Project:
Pinal County Regional Health Clinic - Eloy
Pinal County, Arizona
PN 53330041

ADDENDUM NO. 2
September 9, 2014

SHEET A3.1 REVISIONS

**DIAGRAMATIC CEILING PLAN
- GYPSUM BOARD CEILINGS**

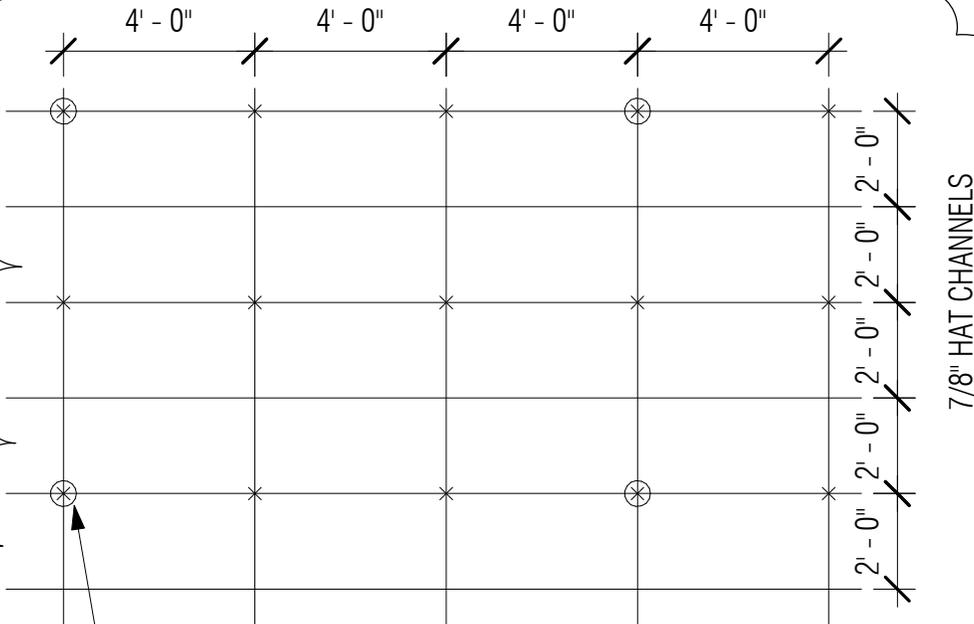
8. What will be the drywall texture?
Drywall texture shall be light orange peel.
9. What light fixture needs to be quoted for the hard lid? (the fixture that is specified will not fit)
Drywall lids have been lowered 8" to accommodate specified light fixtures – Ref. attached A3.1 revisions.

REVISED GENERAL NOTE #6
REVISED DETAIL 7/A3.1 -
CEILING FRAMING

6. ALL GWB CEILINGS TO BE 8'-4" AFF; ALL ACOUSTICAL PANEL CEILINGS TO BE 8'-6" AFF, UNLESS NOTED OTHERWISE.
